re: **Public Notice F-2023-0287**
Hudson Highlands Fjord Trail, Inc. (HHFT)
“Breakneck Connector and Bridge”

Executive Summary

Illustrations on pages 40 and 41 of the 2015 Master Plan

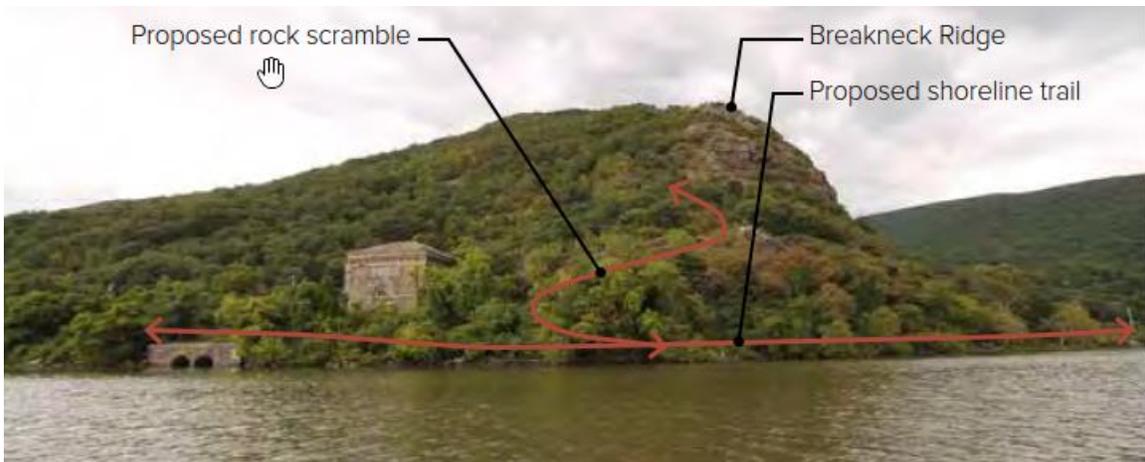
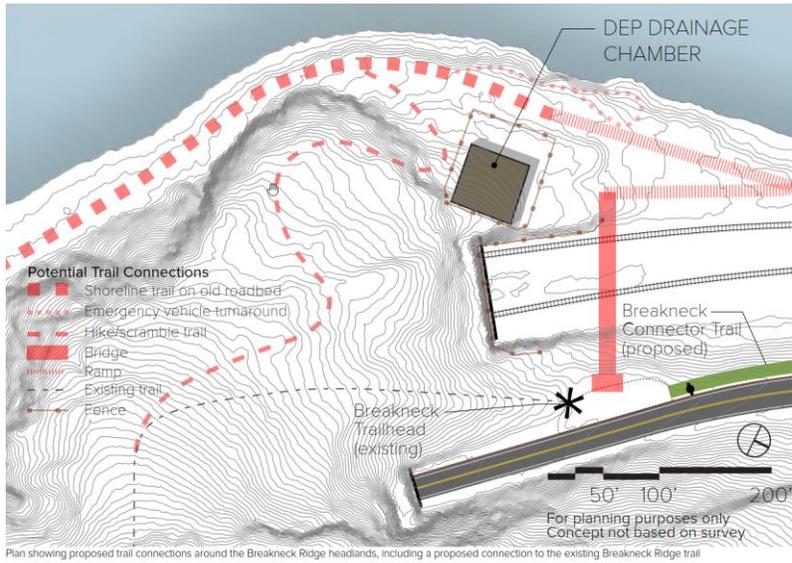
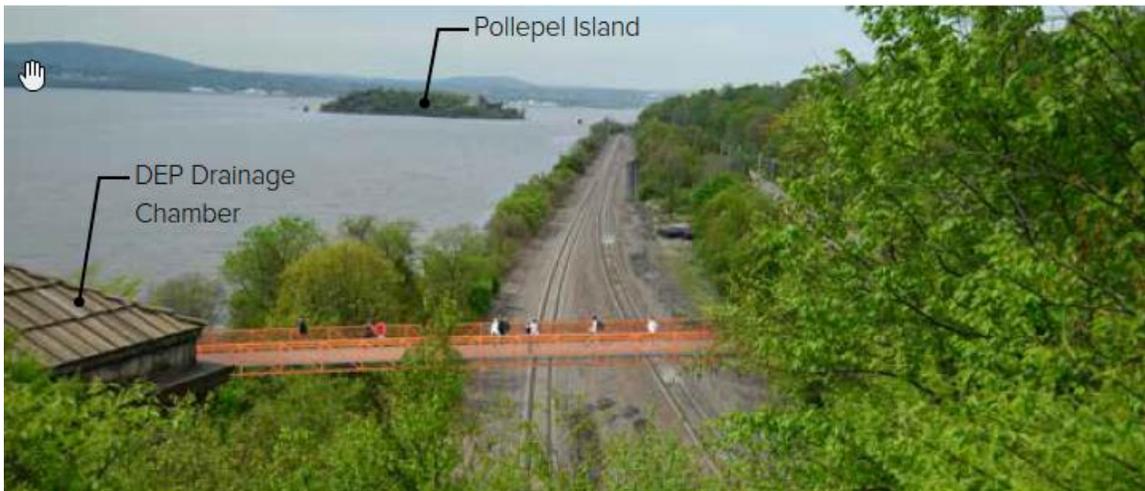
In HHFT’s 2015 Master Plan, still posted on the OPRHP website, the Bridge was to provide “a railroad crossing...in order to connect the proposed route around the Breakneck Ridge headlands...” with the recommendation that “a hiking trail (a rock “scramble”) be blazed for hikers who might want to climb from the proposed headlands trail closer to the water’s edge to the existing Breakneck Ridge trail above.”

Somewhere along the way the connection between the Bridge and the Breakneck Ridge Trail disappeared. **In the currently proposed plan, the trail bypasses the Bridge.** The Bridge plays no part in providing access to the Breakneck Ridge on the headlands or as it continues on the East side of 9D.

Excerpts from HHFT 80 % set Bridge and Overlook Drawings

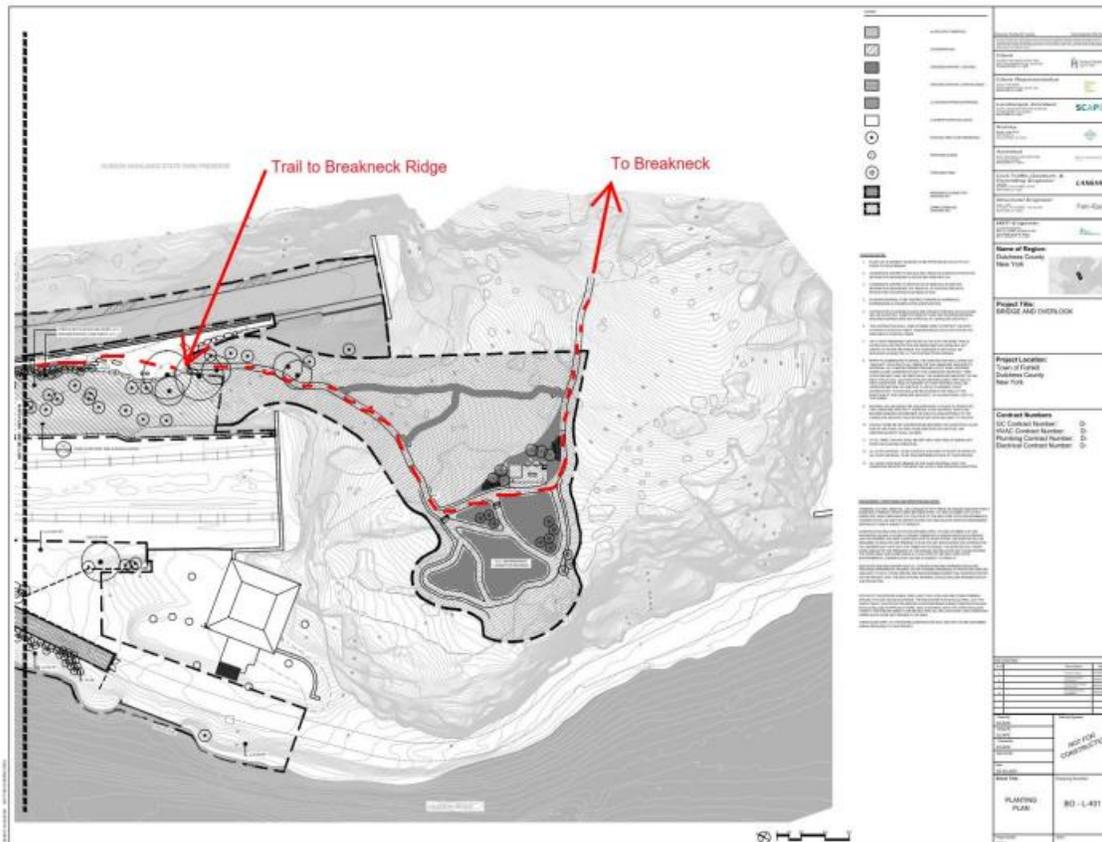
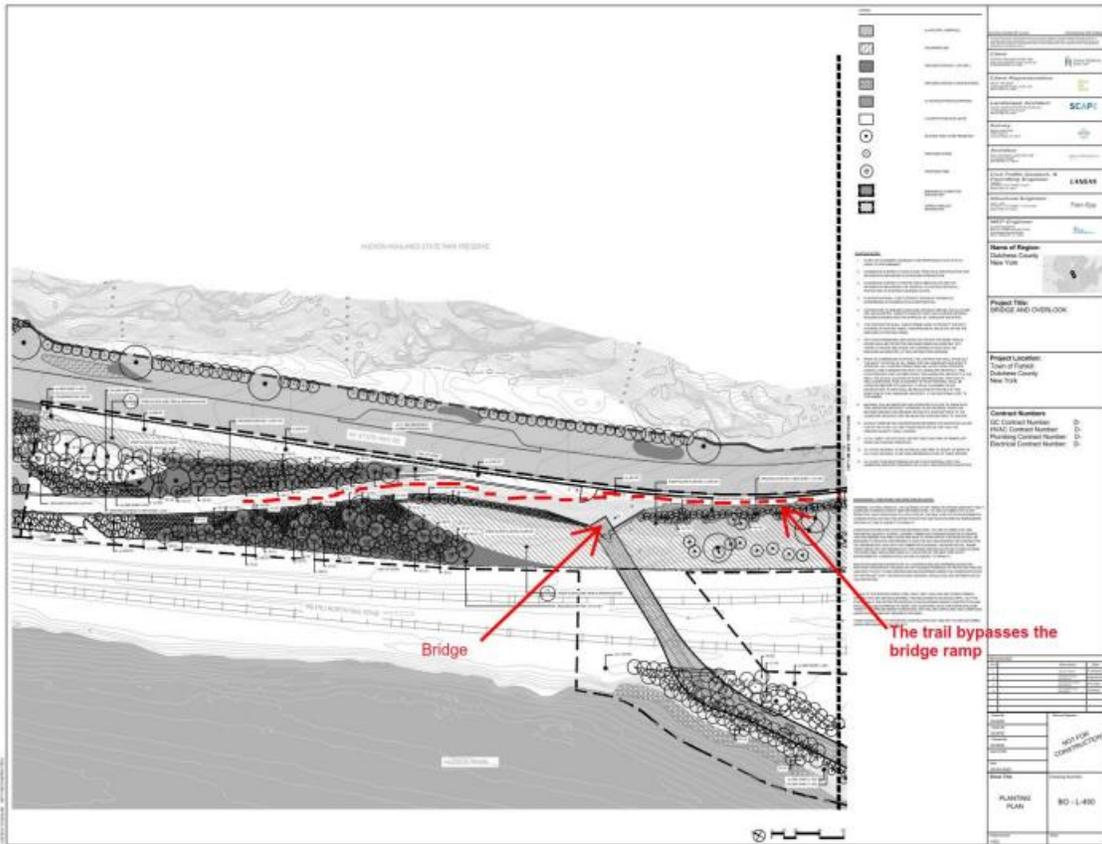
It is important to note that while elements of the Breakneck Connector and Bridge project, particularly those along the 9D corridor North of the Tunnel, may provide independent utility, the Bridge itself does *in no way* contribute to the safety of traffic that arrives by car, rail or foot.

With the Bridge providing no contribution to the safety of visitors, HHFT bases its assertion of the its independent utility on the limited and marginal access it might provide to the NYC DEP's Drainage Chamber structure;

In the event the DEP's CAT-399 project involves heavy equipment or materials, the bridge would be of no utility for what would be a one-time use. The cost of constructing the Bridge, and the environmental damage it would cause in both the long and short haul would far outweigh its utility.
